Response to the comments of reviewer 2 (RC3)

The authors sincerely thank reviewer-2 for his valuable efforts in reviewing our manuscript titled "Passive Microwave Remote Sensing based High Resolution Snow Depth Mapping for Western Himalayan Zones using Multifactor Modelling Approach". The suggestions and feedback shared by the reviewer are highly helpful in enhancing the manuscript. The response to the queries and suggestions provided by the reviewer are attached in the response document below in the point-by-point manner. Kindly note that reviewer comments are in black colour font, response from the author is in blue colour font, whereas the changes made in the manuscript are highlighted in blue colour italic font.

Figure 5. Taylor diagram for the evaluation of multifactor SD models during 2017-2019 for (a) the LHZ, (b) the MHZ, and (c) the UHZ.

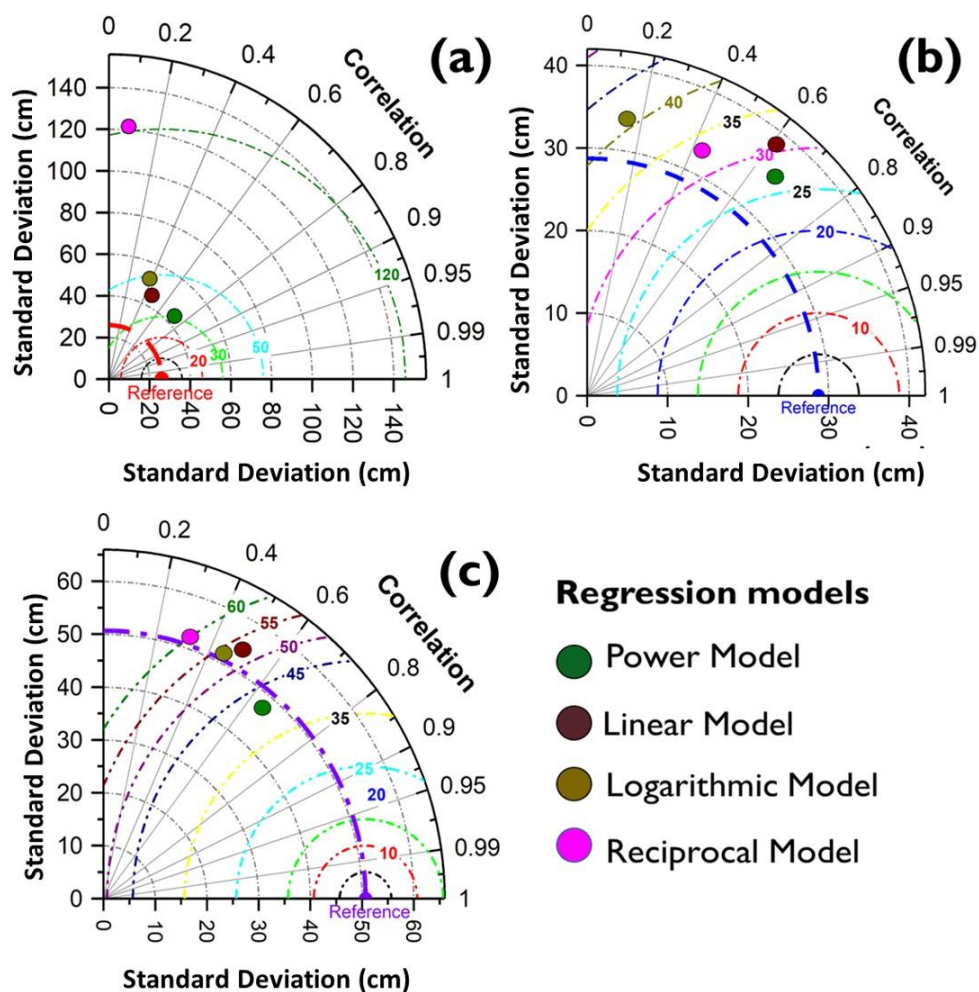
16. Figure 5: Units for standard deviation are missing. Standardizing the standard deviation may improve the interpretability of the figure.

Author response: The units for standard deviation are now updated in the revised figure 5. The standardization of standard deviation is not very common in many of the papers that are published as authors have observed. The origin plotting tool which authors have employed for making the taylor diagram natively does not allow to standardize the standard deviation. Though there are some other python packages and tools available for doing this, the authors have taken feedback from few other members. After consultation, the authors opined that the figure with the standardized standard deviation can also be equally difficult to interpret for some of the community unlike what the reviewer has mentioned. Therefore, authors suggest that it would be simpler to proceed with the same figure 5.

Figure 1. (a) Elevation variability of WH zones (i.e., LHZ: Lower Himalayan Zone; MHZ: Middle Himalayan Zone; UHZ: Upper Himalayan Zone) and DGRE observatories distribution. (Note: J&K, H.P. are Jammu and Kashmir, Himachal Pradesh respectively)

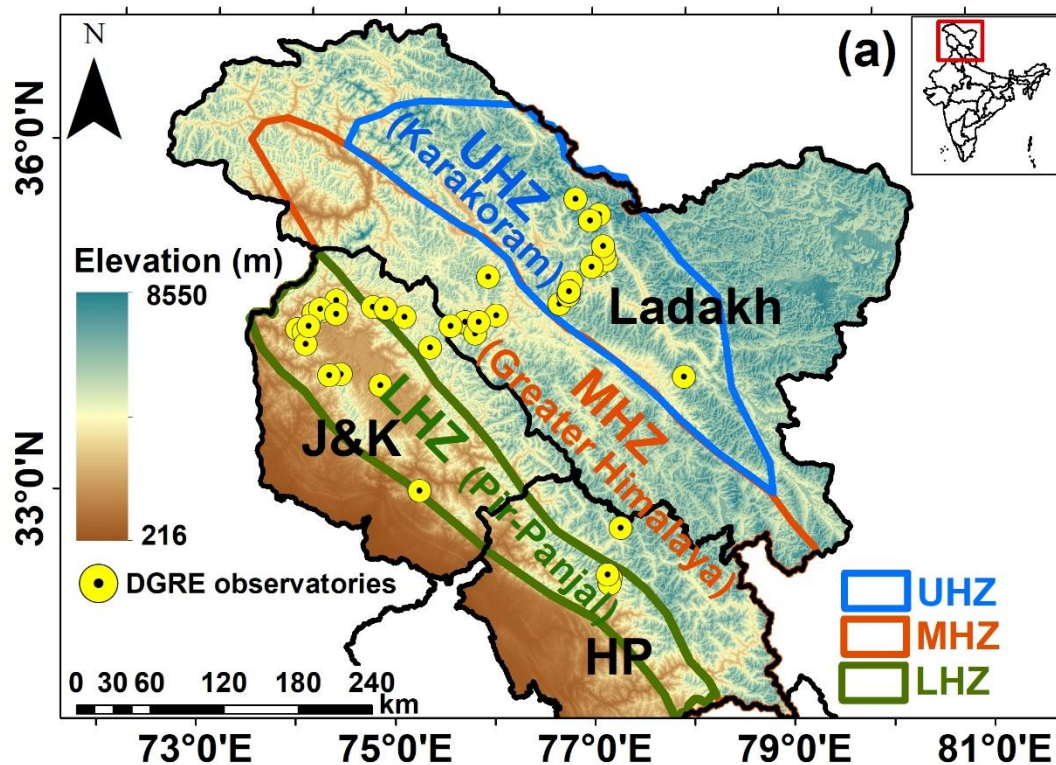
15. Figure 1, Figure 4: The acronyms “J&K” and “HP” are not defined in the figure caption.

17. Figure 6: Where are the Pir-Panjal, Greater Himalayan, and Karakoram regions? Perhaps these regions could be marked in Figure 1.

Author response: The acronyms are now defined in the captions of figure1, and figure4.

Author response: The figure 1 is updated to include the information pointed by the reviewer.

Figure 7: Spatial map of SD variation on 3rd Feb 2019. (a) MODIS SCA, (b) AMSR2_A SD product map at 10 km, (c) AMSR2_D SD product map at 10 km, and (d) multifactor models SD map at 500 m.

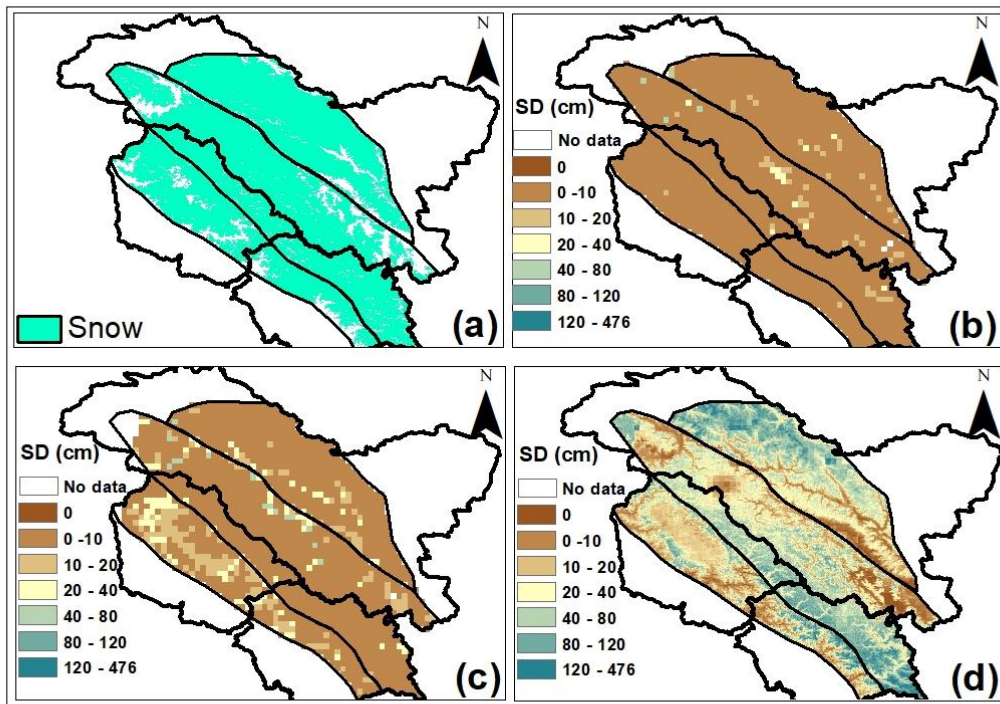
18. Figure 7: The scale for subplots b, c, and d should be the same for comparison, especially at depths of 0 cm and for regions with missing data.

Author response: Thanks for suggesting this. The figure 7 is revised to ensure that that scale is consistent for all the subplots.

Figure 8. Spatial distribution of RMSE of multifactor SD model for varying (a) elevation, (b) slope, (c) land cover types, and SCDs along the 43 ground stations

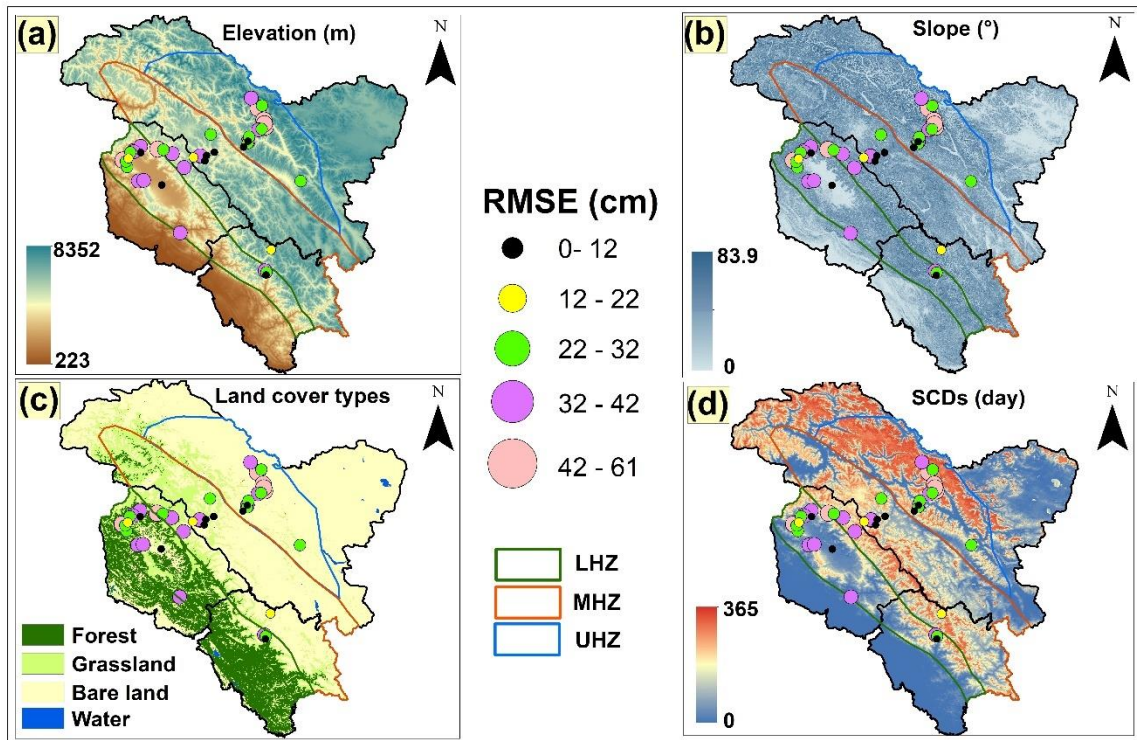
19. Figure 8: RMSE may be better shown as scatter plots so variations in error between elevation, slope, land cover types, and snow cover days are more apparent. As depicted, these patterns are hard to assess visually considering the large study area, scale, and overlap between the stations. Further, this figure is discussed in terms of the lower, middle, and upper Himalayan zones (lines 465-470); however, only state borders are drawn on the map (rather than zone boundaries).

Author response: Figure 8 is updated with boundaries of zones. Additionally figure 9 (i.e., scatter plots) is prepared as suggested by the reviewer. However, the authors believe that it would be difficult to discern any strong pattern even from the scatter plots. This is primarily due to the lesser number of stations and large variation in the error for stations at given elevations. Furthermore, the some of the stations in lower, middle and upper Himalaya have similar elevations despite having different climate and snow conditions. This would add to the complexity in interpreting the accuracy through scatter plots. Further, when it comes to slope, landcover there is not clear pattern in the scatter plot. With regard to SCDs, though no trend is observed it can be seen higher RMSE is present for stations having higher SCD.

Figure: Cumulative distribution of in-situ SD over WH

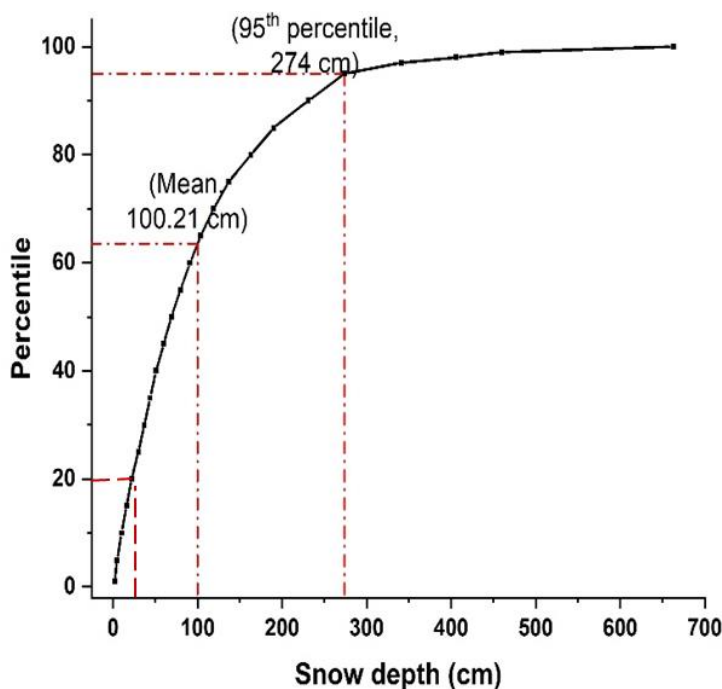
21. Table 6: Was the number of observations consistent between snow depth classes? On line 455 it is stated that only four of the 43 in-situ stations have mean snow depths of less than 25 cm. If there are fewer observations within this class it may influence the resulting error.

Author response: The authors would like to inform the reviewer that the number of samples considered for calculating accuracy metrics in each snow depth class are different. As mentioned in the manuscript, there are only four stations which have a mean snow depth of less than 25 cm. However, it is important to note that all stations have observations with SD < 25 cm, though mean is higher than 25 cm. Approximately 20% of the in-situ SD observations in WH have SD < 25 cm and represent sufficient number of samples in each WH zone. A figure representing the distribution of in-situ SD observations is attached here for reviewer's consideration. The metrics for each SD class is calculated by matching the estimates from each SD product with in-situ observations. Therefore, the authors believe it is acceptable to use the way samples are used for evaluation of model estimates.
